**RE: Application for Appeal of Zoning Permit # 2021-002274
Address: 10 Bethlehem Pike**

**ADDENDUM TO APPLICATION FOR APPEAL
OF ZONING PERMIT #ZP-2021-002274
FOR 10 BETHLEHEM PIKE
ZONING BOARD OF ADJUSTMENT**

BLOCK FRONTAGE [SUMMIT STREET FRONTAGE]

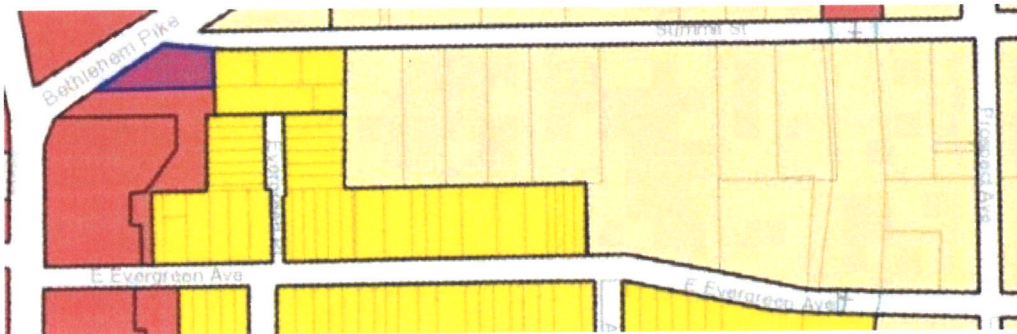
The block frontage along Summit Street (the “Summit Street Frontage”) is divided into three (3) districts, namely: 1) CMX-2 (depicted in red with blue shading below), 2) RSA-2 (yellow below), and 3) RSD-1 (beige below).

RSD-1 is the district that covers the largest percentage of the street frontage on the Summit Street Frontage (as depicted in beige above, it clearly covers well over 50% of the frontage). RSD-1 permits no less than a 35 foot setback from Summit Street. *See Table 14-701-1* of the Phila. Code. Therefore, per § 14-701(1)(c)(pre-March 29, 2021), any structure the Applicant builds at the Property must have no less than a 35 foot setback from Summit Street. The proposed project calls for a zero (0) foot setback along Summit Street. Thus, the proposed project is not permitted under the Zoning Code.⁵ Therefore, this application should have been refused, and now the ZBA must overturn the decision of L&I and revoke the Permit.

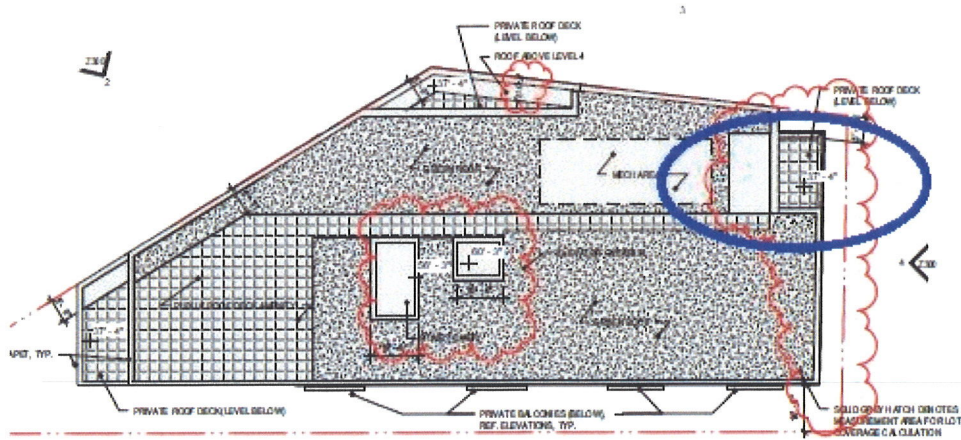
The proposed Roof Deck on the eastern side of the property would be set back from the front building line zero (0) feet. The Zoning Code at § 14-604(5)(a) requires that any Roof Deck be set back *at least five (5) ft.* from the front building line. A screenshot of the relevant portion

of the Applicant's Zoning Plans is copied below (with a blue oval added to identify the improper Roof Deck):

This eastern-most proposed Roof Deck clearly does not comply with the set back requirements of § 14-604(5)(a). Further, it is unclear if the other proposed roof deck along the street frontage is in compliance with this provision. Therefore, this Zoning Permit was improperly issued by L&I and must be revoked.
